Delegated Report

Householder Planning Application

Planning Application No: 20241107

Location: Dunelm, Woodlands Lane Shorne Gravesend

Previous proposed plans as per Application 20240123:

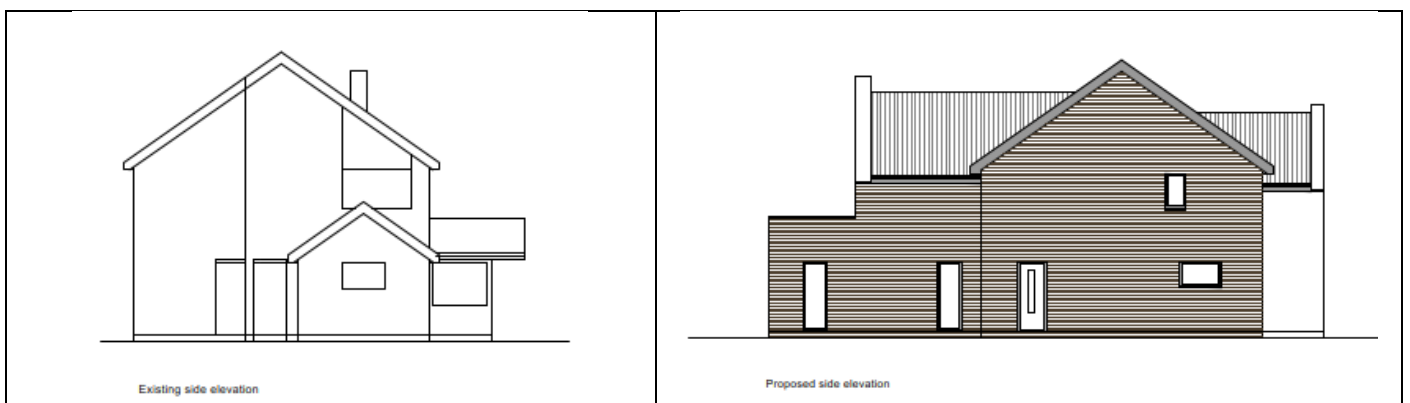
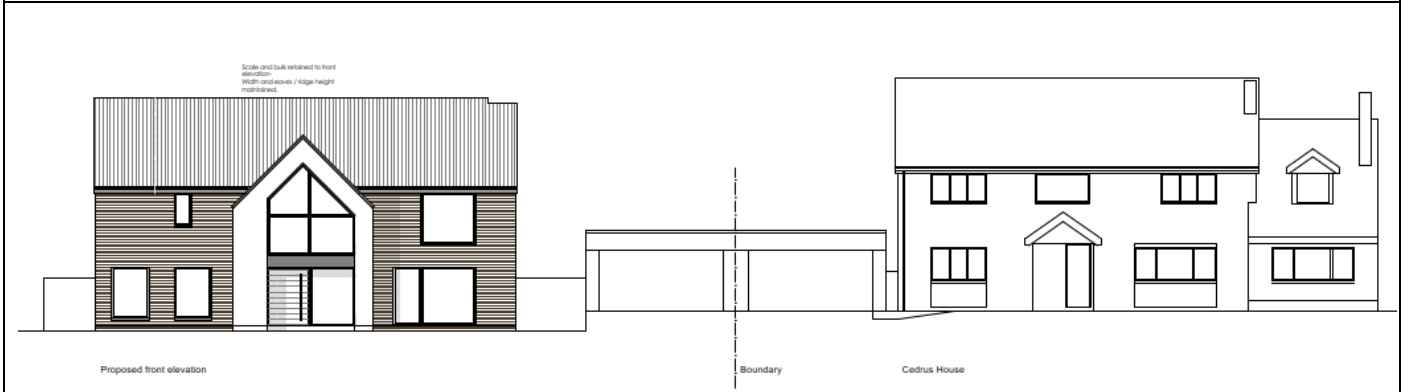
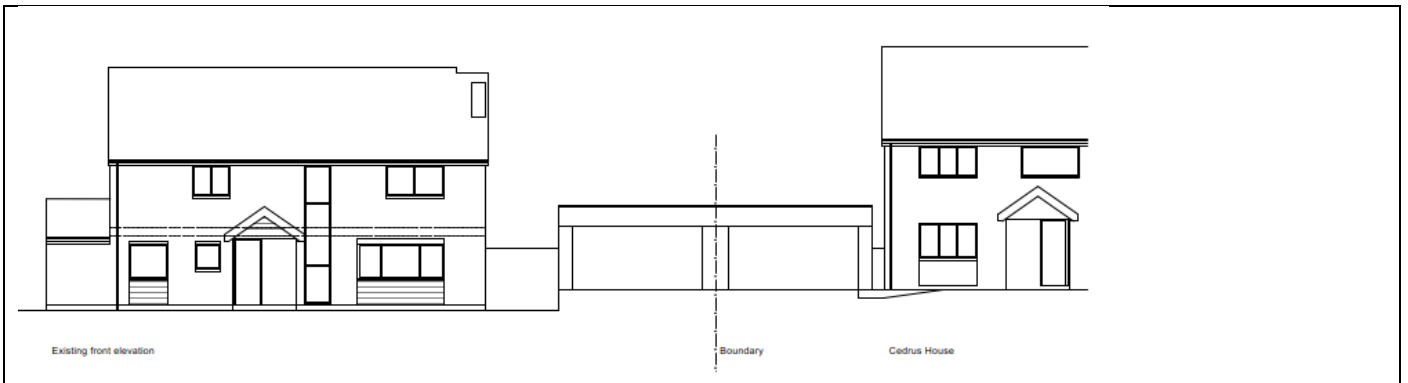
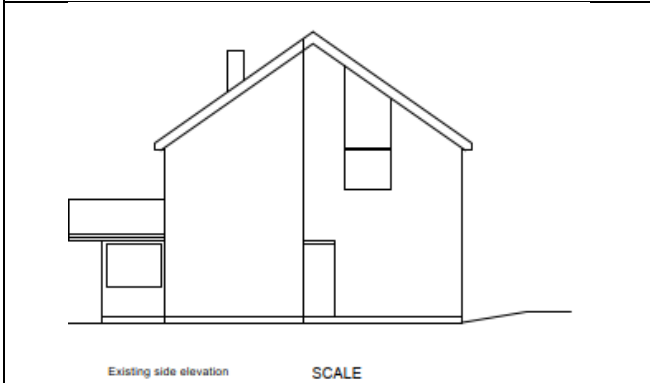
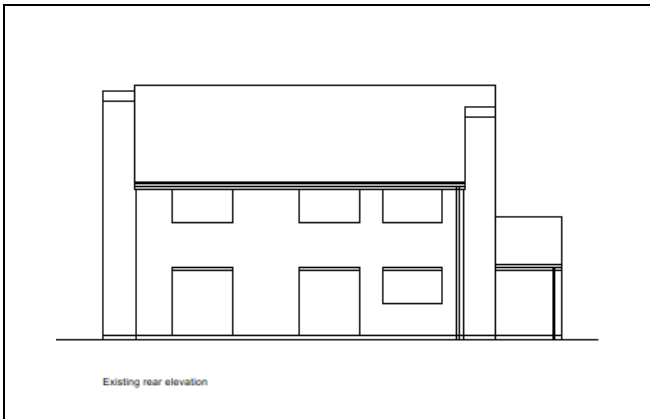
It is noted that the scale of the proposal has been reduced, with some elements altogether omitted, since the refusal of application 20240123, which is desirable. Ideally, the proposed extension closest to Three Elms would be set down from the main roof ridge and set in from the front elevation to demonstrate subservience to the main dwelling, particularly as the extension would be visible from the street scene. In addition, it would be preferable for the porch roof height to be further reduced. Notwithstanding this, the alterations made as a result of the site meeting are considered to be an improvement on the submitted proposal. Therefore, on balance, the overall bulk/massing/subservience is considered to be acceptable.

The depth of the proposed rear extension has been somewhat reduced since the previous proposal, however, the plans show the extension would extend across the entire width of the dwelling, inclusive of the new proposed side extensions. Although the Design and Access Statement refers to what could be constructed under Permitted Development Rights, this has not been established via a Lawful Development Certificate Application. Regardless of this, the single storey rear extension in situ, with staggered appearance, is, on balance, considered to be acceptable.

Fenestration

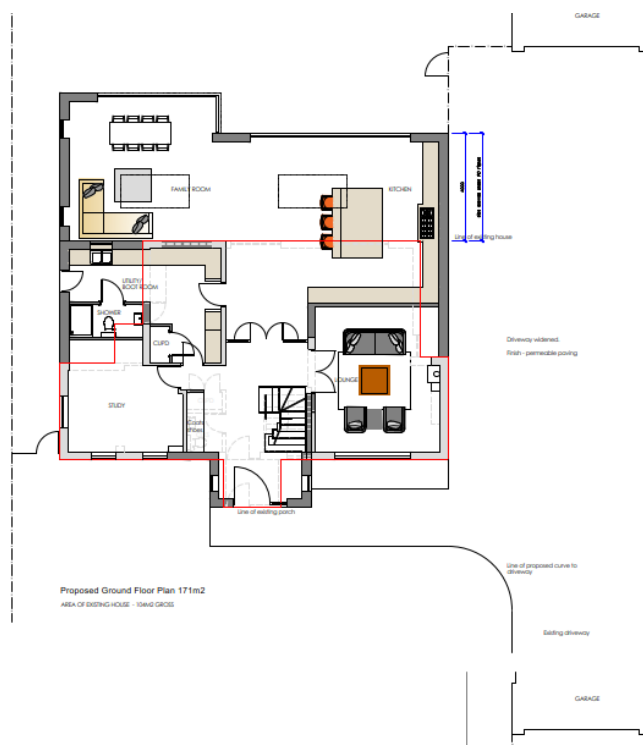
The size/positioning of the fenestration has been improved and is now considered to be acceptable.
